Re: Tract N-1-B Watershed Subdivison - Sketch Plat Submittal

REQUEST: Sketch Plat review for Tract N-1-B Watershed
IDO -2022

Development Facilitation Team (DFT) – Review Comments

Project No: PR-2024-010571 **Date:** 7/3/2024 **Agenda Item:** #12 **Zone Atlas Page:** J-8

SHEET NO. 1 OF 1

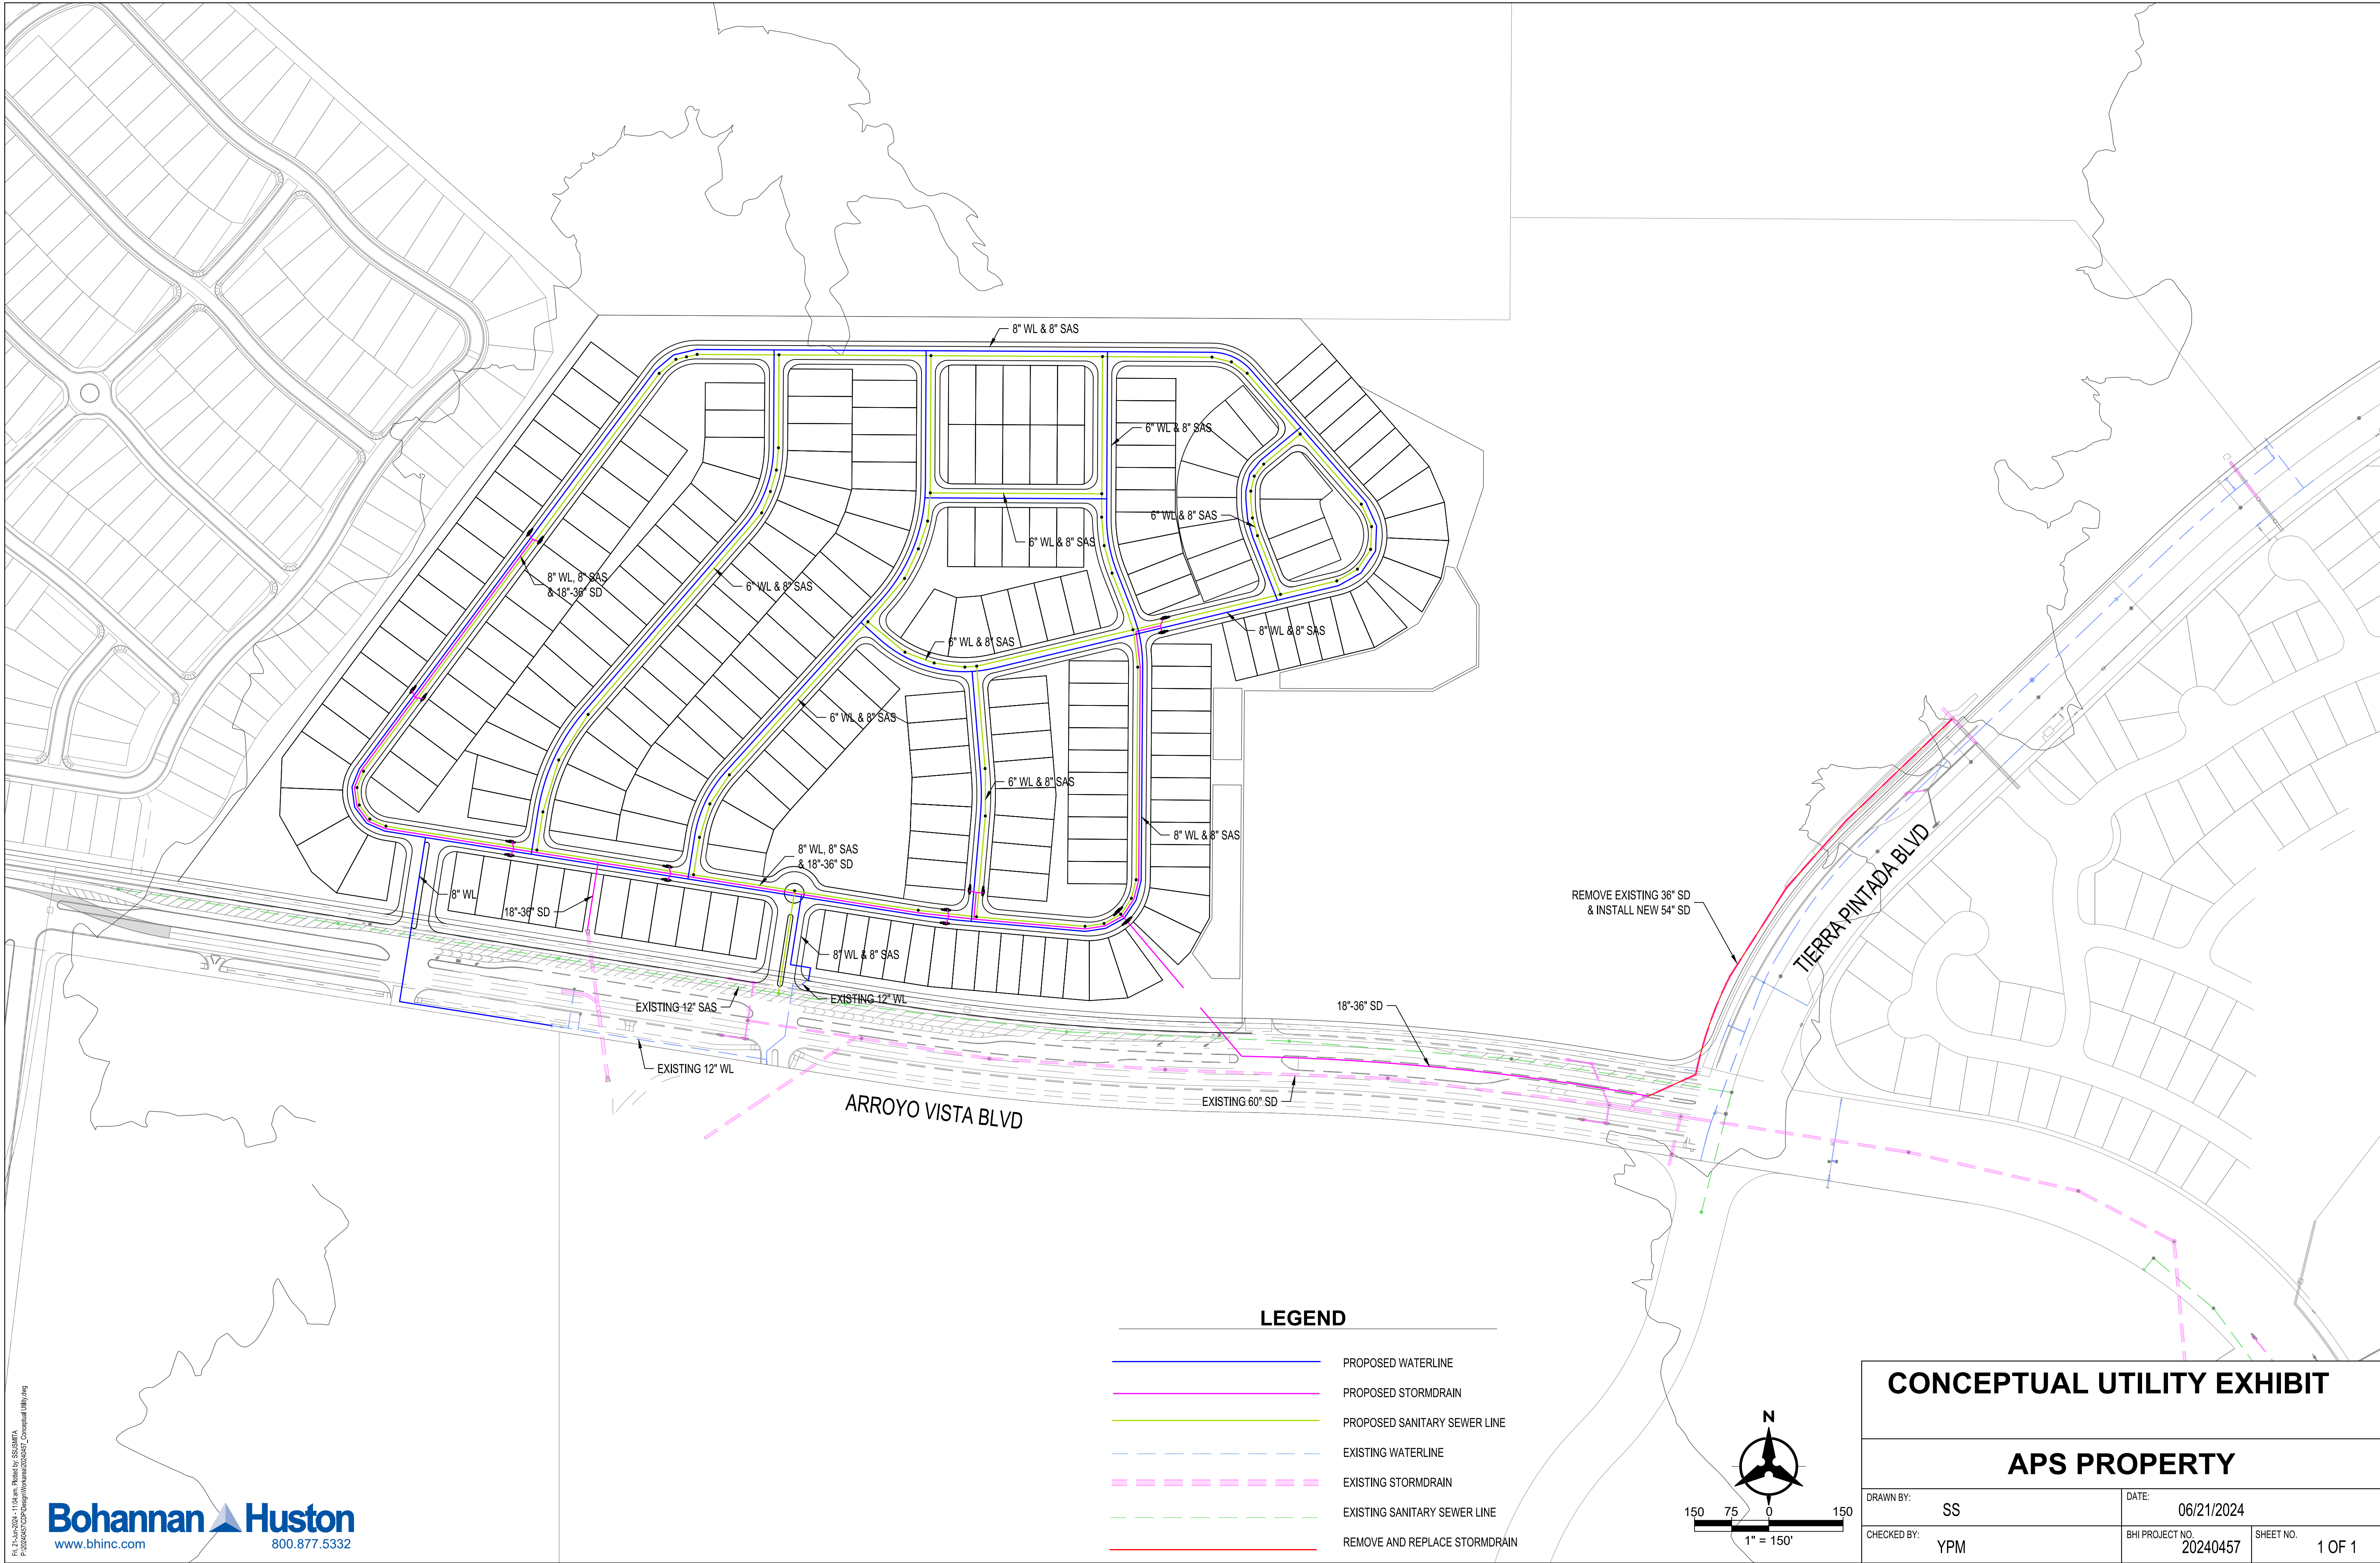
1. Request an availability/serviceability statement online at the following link:
http://www.abcwua.org/Availability_Statements.aspx. Requests shall include fire marshal requirements. An executed statement must be obtained prior to approval.
2. Regarding the comment for water, please provide a maximum pad elevation for the site to determine if there is any need for 5W infrastructure.
 - a. Note that the highest contour I see for the site based on our mapping system is right at the 5W/4W pressure zone boundary at 5485 feet which is evident the entire site currently sits within the 4W pressure zone thus not requiring a PRV to provide pressure to the site.
3. As proposed the site is on a really long dead end line and will require some sort of loop. Perhaps to the adjacent site on APS site which will create a good looped water system to provide redundancy for the future development.

1. Arroyo Vista is a Principal Arterial and requires a 6' sidewalks with a 5' to 6' landscape buffer. There is an existing multiuse trail along here which meets sidewalk requirements.
2. All internal roads would be local roads and require 5' sidewalk with a 4' to 6' landscape buffer.
3. Prior to site plan an approved TCL is required. Also, please submit a Traffic Scoping Form to Curtis Cherne (ccherne@cabq.gov) to determine if a TIS is required.

- Hydrology will need to approve a Conceptual Grading & Drainage Plan prior to platting.
- The infrastructure list will be needed for Preliminary Plat.
- Hydrology will also need AMAFCA's approval prior to plat approval.

- Platting applications would be subject to review and approval by the City of Albuquerque/Development Hearing Officer (DHO). residential would be >>>>>
- The western tract (proposed Tract N-1-B in this sketch plat) is a proposed residential subdivision, and not an educational land use. The parcel is subject to the requirements of the Westland Framework Plan and the IDO and DPM where the Framework Plan is silent. As the Westland Framework Plan depicts the subject property as an Education land use, any other future land uses on the site requires an amendment of the Westland Framework Plan, requiring EPC or City Council approval of the amendment. DRS Planning staff advises the applicant to schedule a PRT meeting with UDD staff regarding this step.

- Tract N-1-B is located adjacent to Petroglyph National Monument and lies outside the boundaries of the City of Albuquerque. The developer should coordinate with Petroglyph National Monument. The development must comply with all the following sections of IDO 5-2(J)(1) Lots within 330 Feet of Major Public Open Space, 5-2(J)(2) Lots Adjacent to Major Public Open Space, and 5-2(J)(2)(c) Lots Adjacent to the Petroglyph National Monument. An important provision is 5-2(J)(2)(b)(10)

This site requires a Site Plan EPC prior to subdivision of land with the DHO.

It is noted that a single-loaded street has been placed on the edge of the subdivision adjacent to Petroglyph National Monument which meets of the requirements of 5-2(J).

It would appear that you have been able to keep some block lengths under 600 feet, but some are not.

BACKGROUND

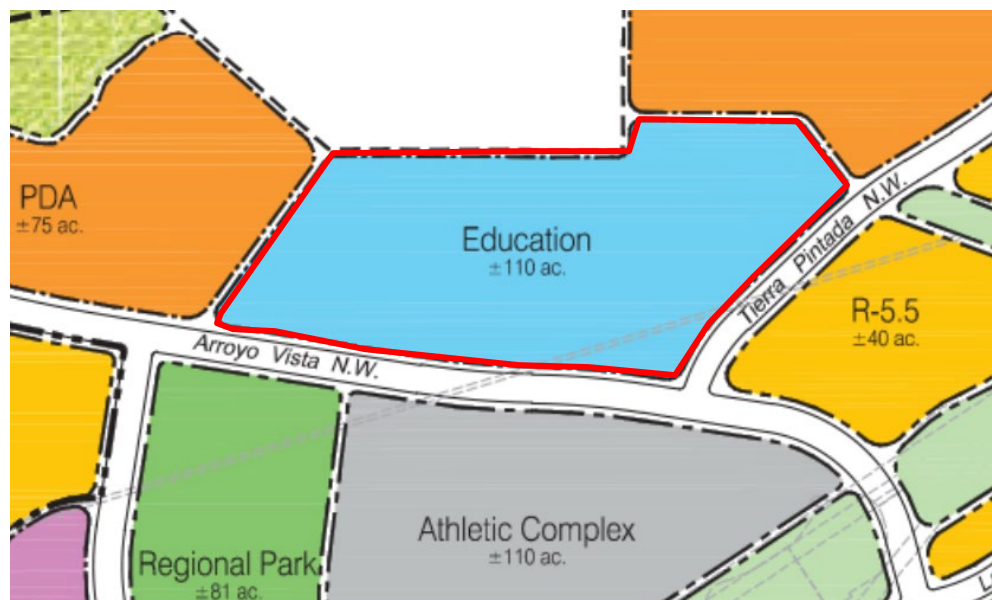
- A previous sketch plat was reviewed April 17, 2024. That Sketch Plat review request was for a Bulk Land Plat, subdividing an existing tract, Tract N-1 of the Watershed subdivision, into Tract N-1-B at 60.0839-acres in size and Tract N-1-A at 49.9-acres in size. **Tract N-1-A and Tract N-1-B still need to be created. Tract N-1-B could then be further subdivided.**

- The subject property is zoned PC (Planned Community), is located at 9601 Tierra Pintada Blvd., and features the Tres Volcanes Community Collaborative School on the eastern portion of the subject property (future Tract N-1-A as depicted on the Sketch Plat). The western portion of the property is vacant (future Tract N-1-B). The parcel is owned by Albuquerque Public Schools (APS).

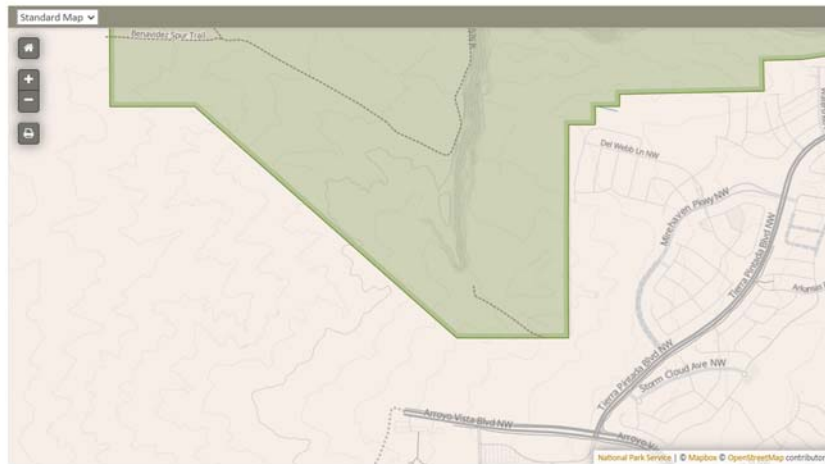
The subject site is adjacent to MPOS (Petroglyph National Monument) along the northern property line.

6-5(G)(1)(e) Where adjacent to Major Public Open Space, a Site Plan – Administrative may only be approved for a project site of no more than 5 acres. Development on a project site over 5 acres and adjacent to Major Public Open Space requires a Site Plan – EPC pursuant to Subsection 14-16-6-6(J).
